RE: JMC Project 15024
 ARB Amendment Golden Vista
 Meadow Hill Rd
 Town of Newburgh, NY
 Town of Newburgh Project No. 99-33

MEMORANDUM

Date: January 20, 2016
 To: Town of Newburgh -- Planning Board
 From: Bruce Englebaugh, AIA
 Project: DRA Meadow Hill, LLC; "Golden Vista", Newburgh, NY
 Subject: Summary changes made to the architectural concept after site plan approval.

UNIT PLAN COMPARISON

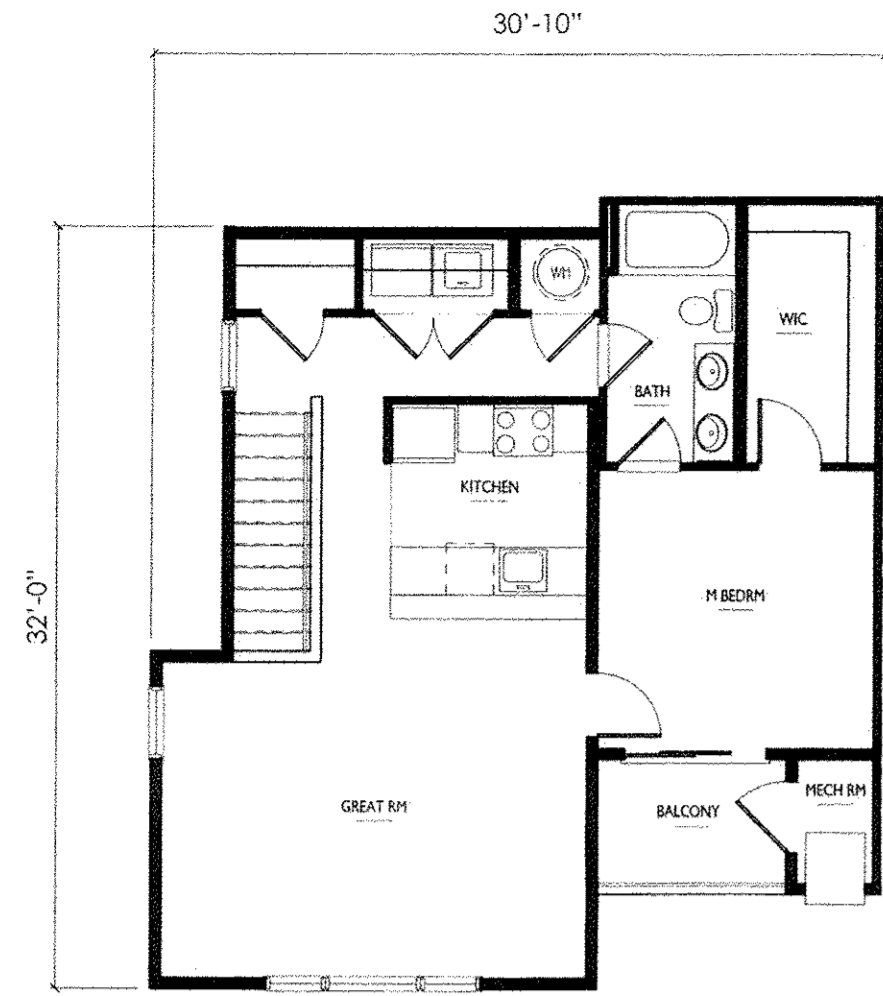
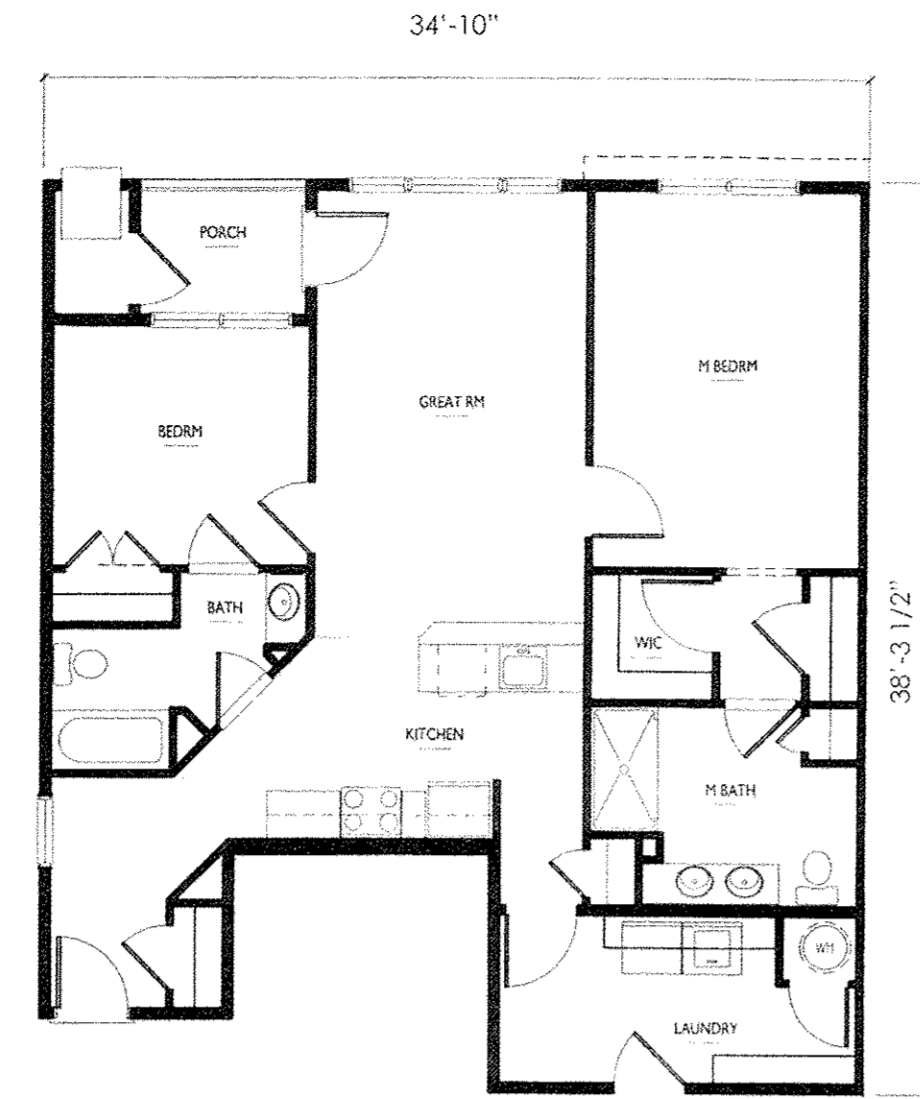
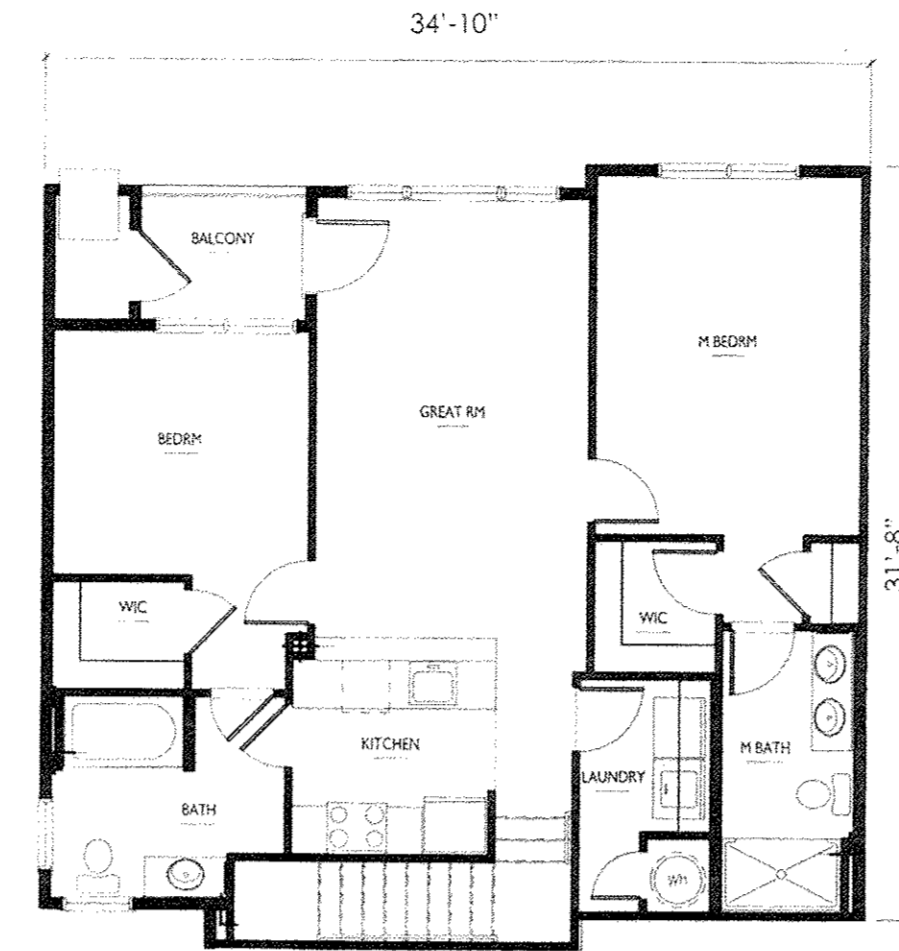
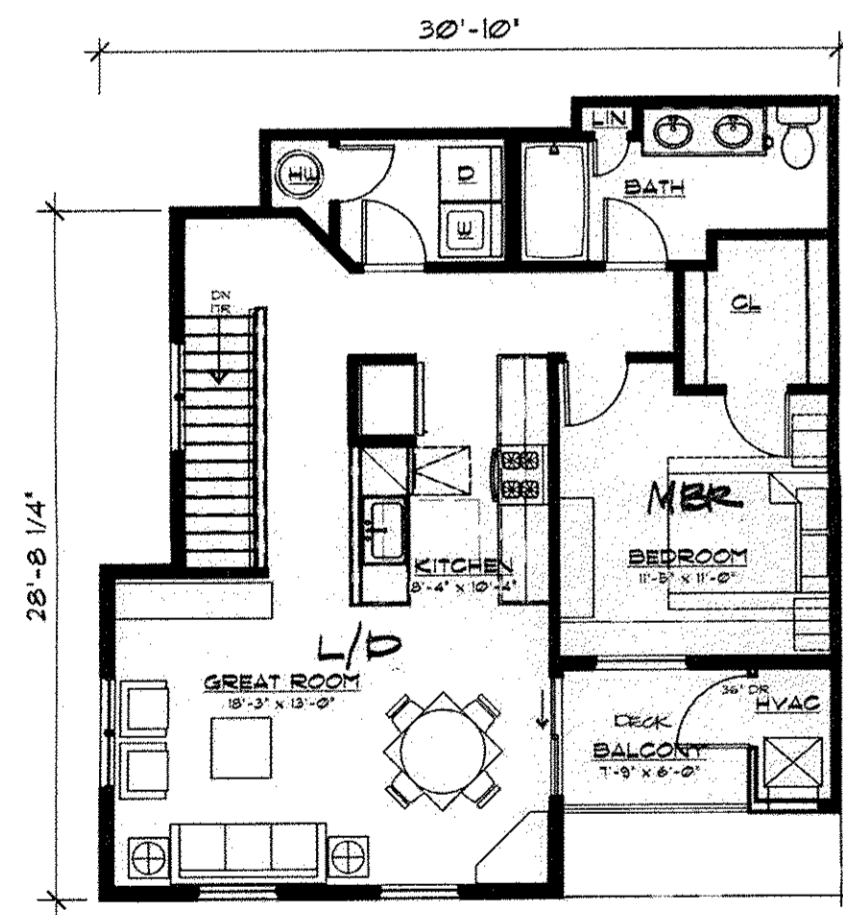
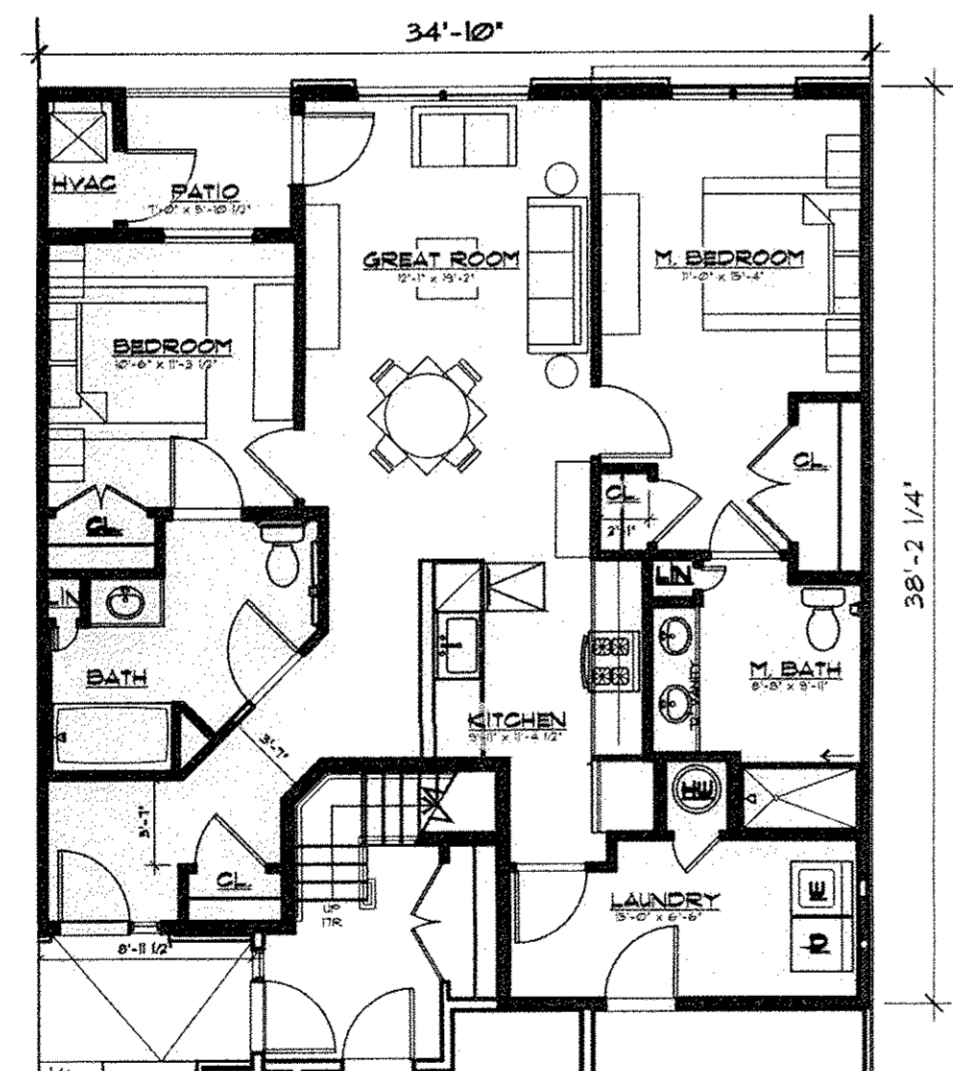
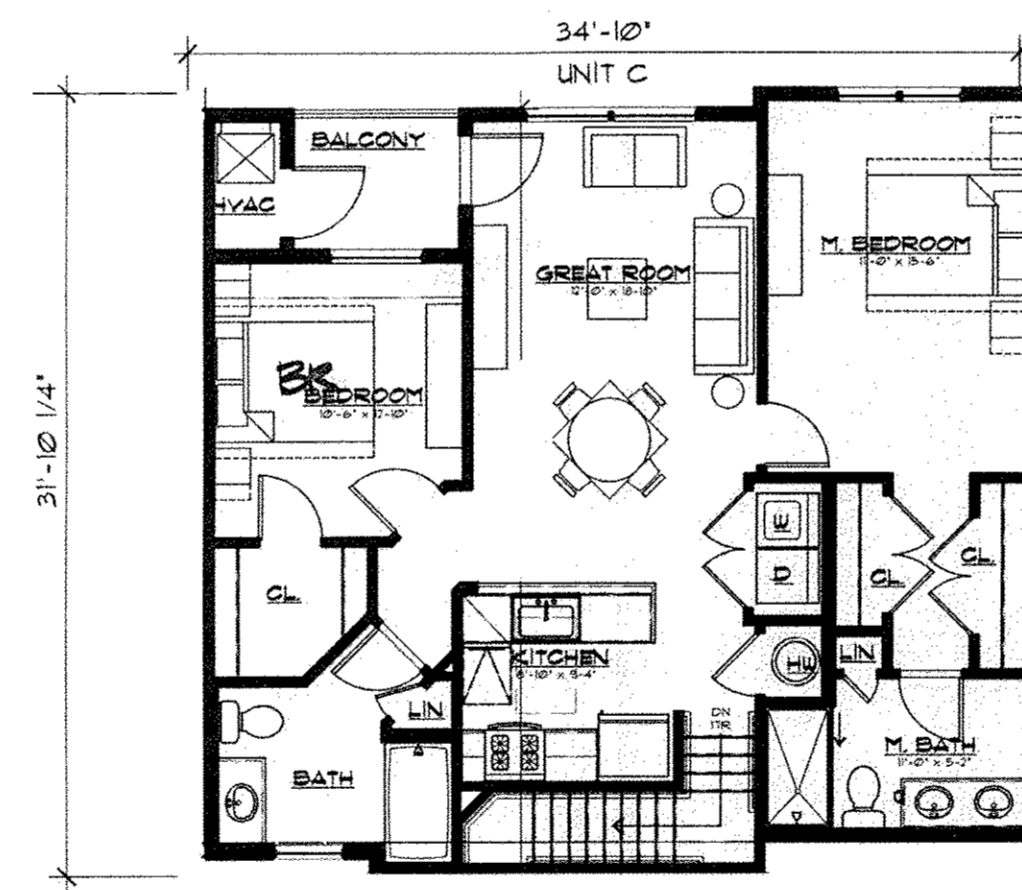
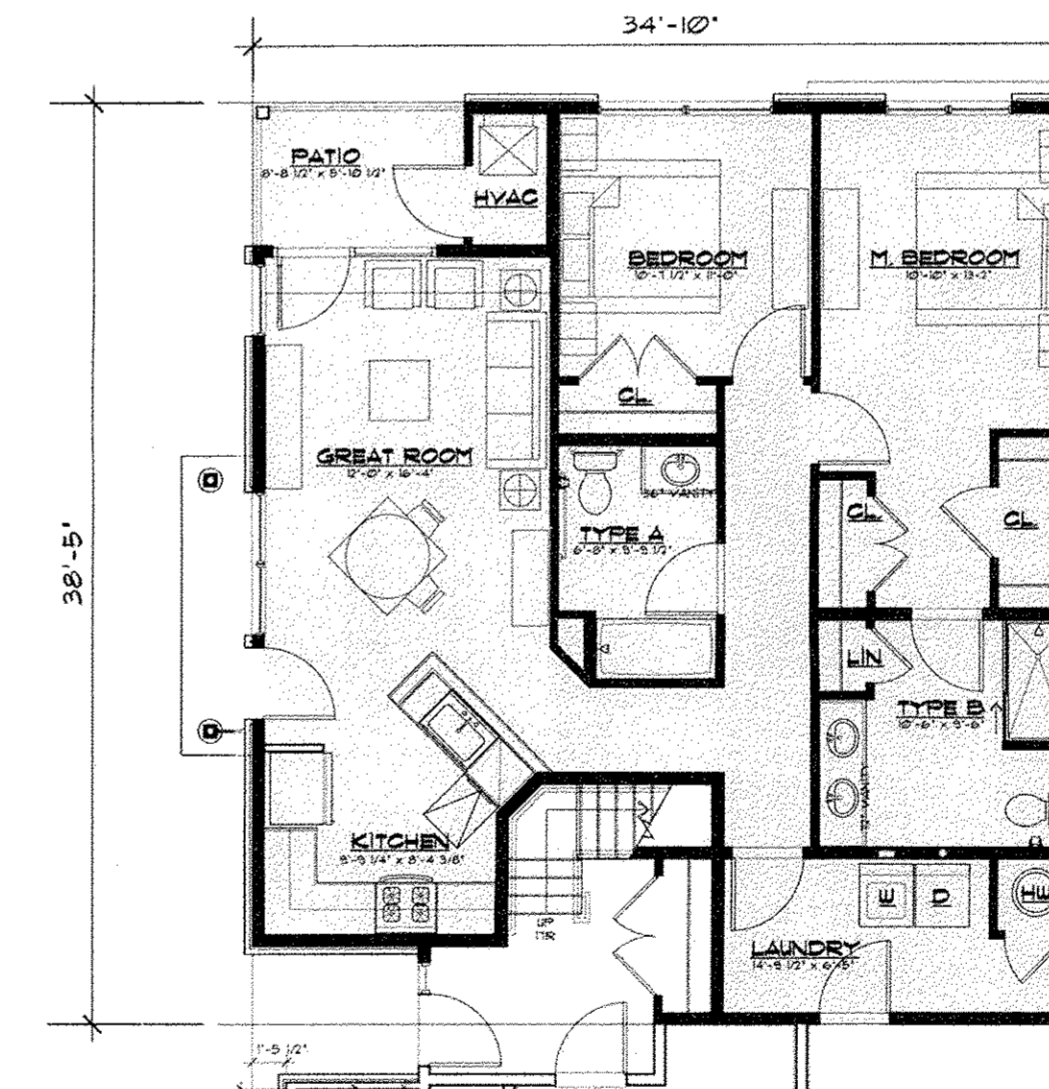
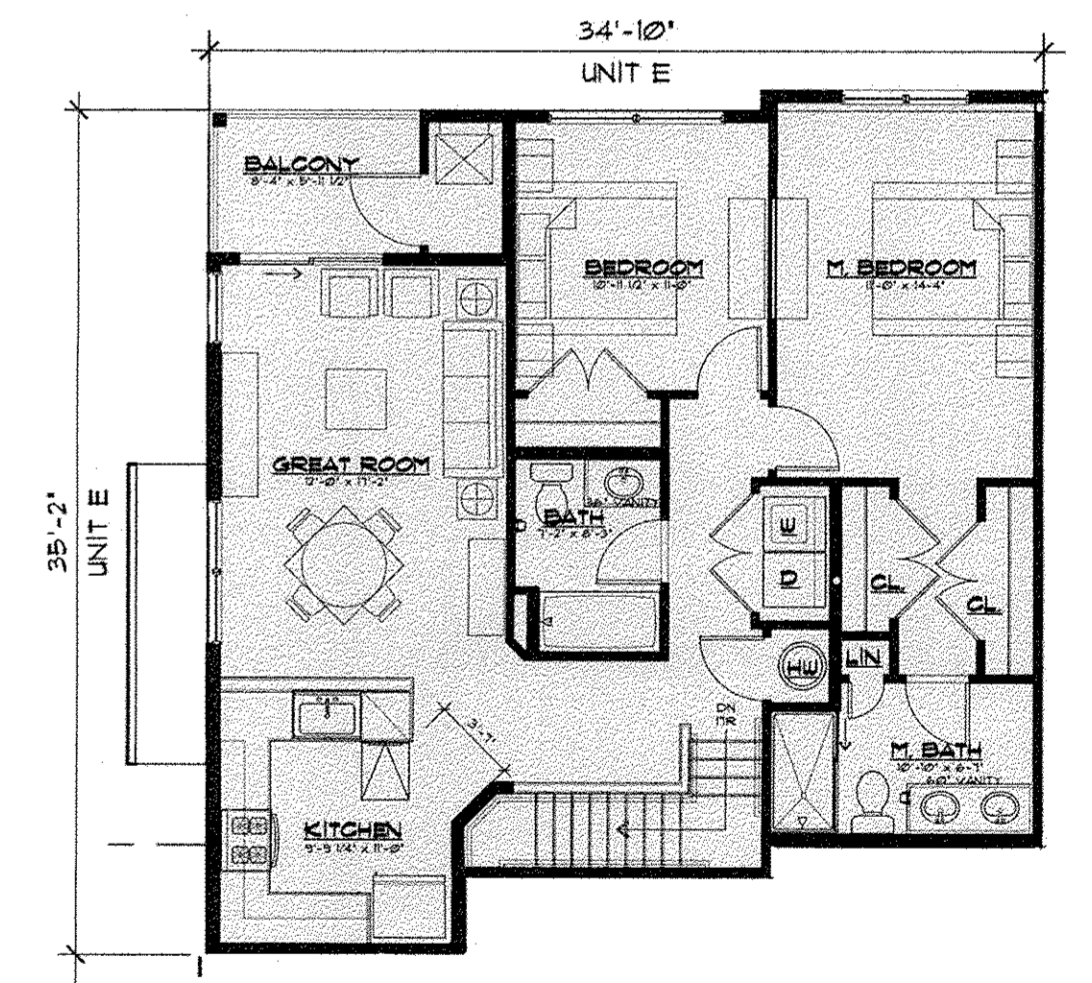
4. Unit Types: Two additional unit types were added to respond to end conditions at each building. The new end unit designs place the major spaces (Living/ Dining/ Kitchen) on the end walls, this allows for more window area that increases marketability of the end units and also provides for a more attractive façade design at end of the building. The end units also indicate a corner deck.

5. Unit plans were changed to conform to the NY state barrier-free requirements and were also changed to improve "flow", marketability, and constructability.

6 of 7
12 UNIT - ELEVATION COMPARISON
DATE: 12/03/2015

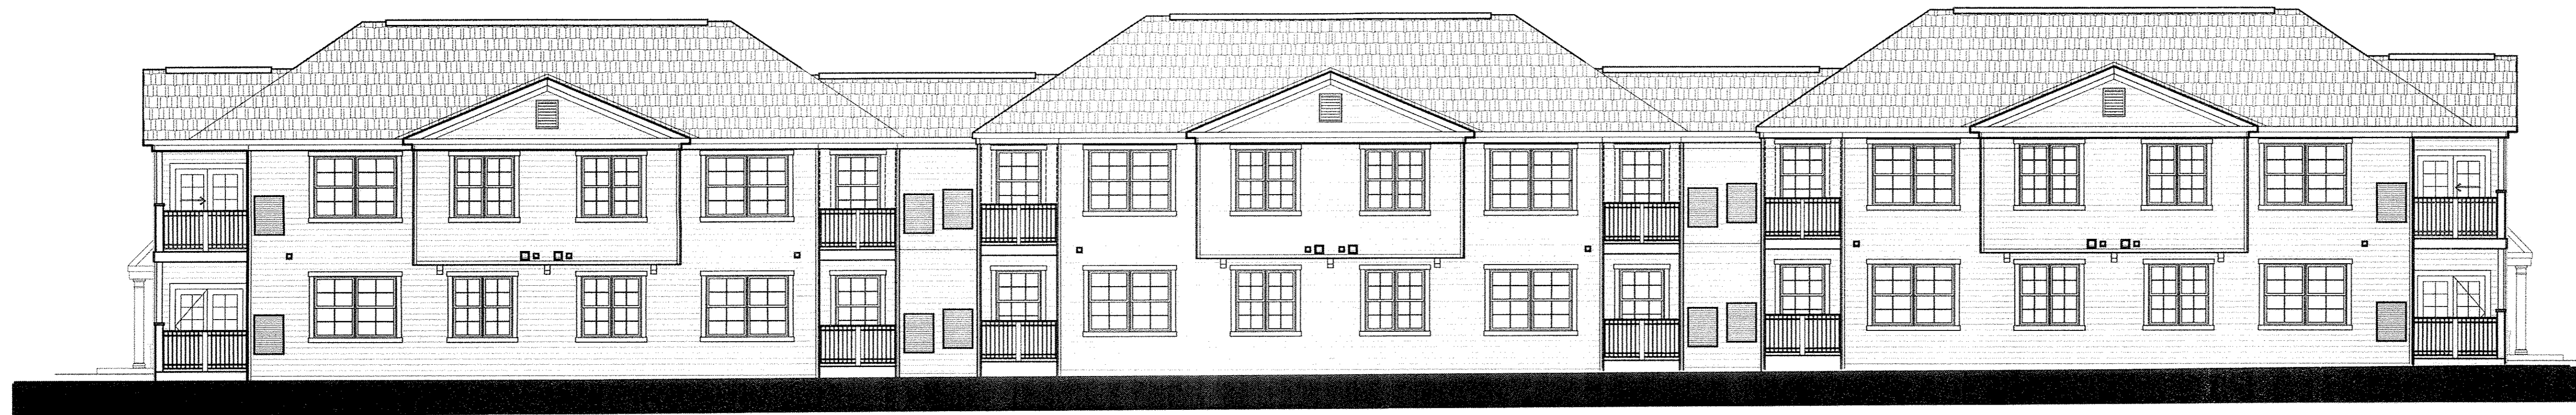
3. Roof-line: The roof on the approved scheme had gable ends, the new M&W scheme proposes hip roof for the primary roof and gable ends for accents. The hip roof concept helps to visually break down the scale at each end of the building. The hip roof also increases the amount of daylight and air circulation within the entrance courtyards.
